APPLICATION NO.	FILING DATE	FIRST NAMED INVENTOR	ATTORNEY DOCKET NO.	CONFIRMATION NO.
10/812,324	03/28/2004	George H. Gibbens III	6541-0403	2688

## Office Action Summary

### **DETAILED ACTION**

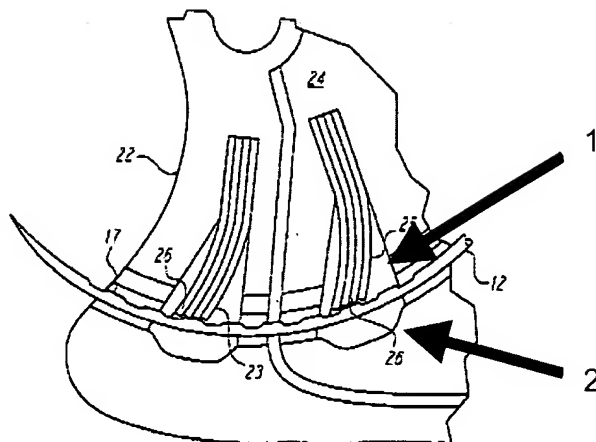
8. Claim 1: Taylor'727 discloses a suturing device that contains a curved needle (12); a first plurality of one-way engaging devices (25, 25) that selectively engage the curved needle (see Figure 7, 7a and column 3, lines 30-65); an arcuate reversing housing (16) that is concentrically positioned around the curved needle for changing the direction of the engaging device (Figures 1, 7, 7a); and an arcuate driver (24) that is concentrically positioned within the arc of the curved needle. The arcuate driver moves along a path (column 4, lines 55-57) and is adapted to pivot the plurality of engaging devices to engage the needle (column 3, lines 30-35 and column 4, ines 53-63). The arcuate driver also has a plurality of circumferentially spaced cavities (see arrow 1 in the Figure 7a below). The engaging devices are contained within the cavity (see Figure 7a). Further, Taylor'727 discloses a fixed way (22) that provides a path for the arcuate driver.

11. Claim 5: The arcuate reversing housing also contains a plurality of spaced cavities for the first plurality of one-way engaging devices (see arrow 2 in the figure for claim 1 rejection above).

12. Claim 4: Taylor'727 discloses a method of surgically suturing (column 1, lines 5-15) that includes providing a driver (24) having a cavity (see arrow 1 in figure for claim 1 rejection); providing a blade (25) with a slot (movement of flexible fingers 26 creates slots for engaging; column 3, lines 30-49) wherein the blade is mounted within the cavity (see Figures 7, 7a). Next, pivoting the blade within the cavity engages the interior surface of the slot and the needle (see Figure 7a). Next, the blade is driven in a first

13. Claim 6: Taylor'727 discloses a suturing device that contains a curved needle (12) and an arcuate driver (24) that is positioned within the arc of the curved needle. The arcuate driver moves along a path (column 4, lines 55-57) and has a first plurality of circumferentially spaced cavities (see arrow in the figure above for Claim 1 rejection). Further, the device contains a plurality of blades (25, 26) carried within the cavities of the driver. One end of each blade is received within the cavity (see arrow 1 in the figure for Claim 1 rejection above). There is also an arcuate reverser (16) is positioned around the curved needle. The reverser also has a second plurality of circumferentially spaced cavities and part of the blade is place within these cavities (see arrow 2 in the figure for Claim 1 rejection above).
